From: Selim <Selim@sawayaeng.com>
Sent time: 02/20/2019 10:53:59 AM
To: Rehm, Zach@Coastal <Zach.Rehm@coastal.ca.gov>; So Kim
Cc: Ara Mihranian; Jill Martin <jmartin@trumpnational.com>
Subject: RE: Tract 50666 Fencing plan

- 1) I'm ok with your comments from the previous email below. In doing one last final check, please make the 2 additional minor changes.
- 2) Change the notation "12' HIGH LANDSCAPING" to "LANDSCAPING NOT TO EXCEED 12' IN HEIGHT OR THE RIDGE ELEVATION OF THE SOUTHERLY BERM". Based on your map, it appears that the ridge elevation of southerly berm would be 225.

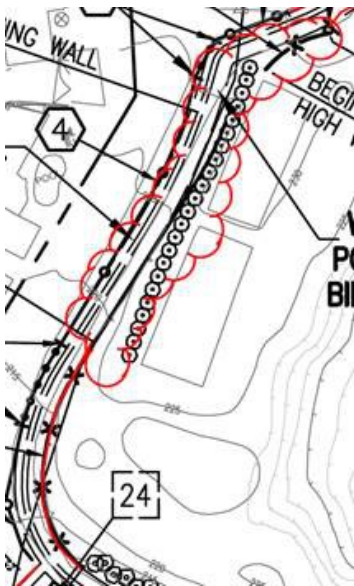
- 3) Based on Mitigation Measure H-1 above, remove the 6' tall fence located in the bubbled area since there is already a hedge there and begin the fence from the south end of the west hedge to the west end of the south hedge as shown in the solid red line below. Please change the notation from "6' HIGH LATTICE" to "LATTICE FENCE NOT TO EXCEED 6' IN HEIGHT OR THE RIDGE ELEVATION OF THE SOUTHERLY BERM". I understand that by doing so, there may be a gap between the west hedge and the new fence.
